Model series 190 cracking between loading floor and side trunk lining

Topic number	LI68.30-P-063994
Version	1
Design group	68.30 Coverings, trim
Date	05-02-2016
Validity	AMG GT (190)
Reason for change	
Reason for block

Positionierung Schablone.JPG:

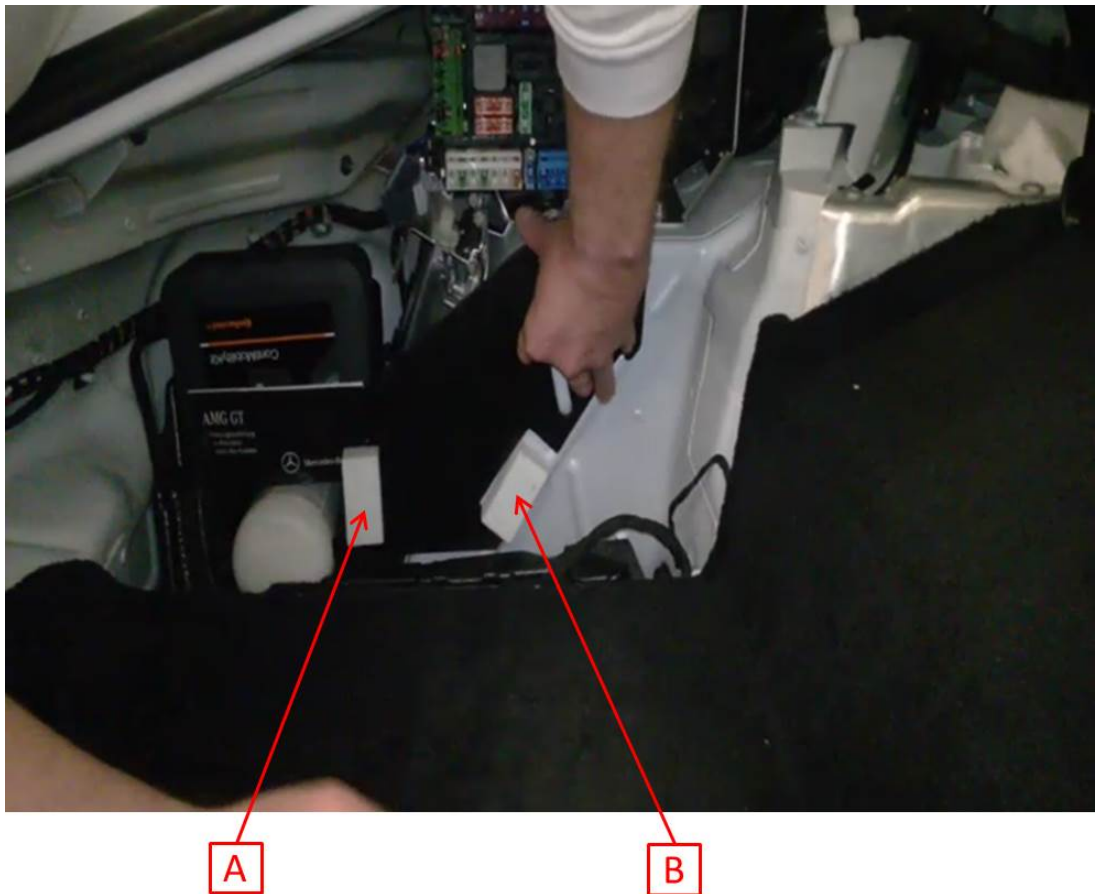
Gap between loading floor and side trunk lining

Gaps that were identified in loading floor.

1. Remove lining at side of trunk, see ar68.30-p-4800rg.
2. Print out template (see Attachment) in DIN A3 format.
3. Position template, see picture 1.
4. Position block of foam, see picture 2, Position A and B. press firmly on.
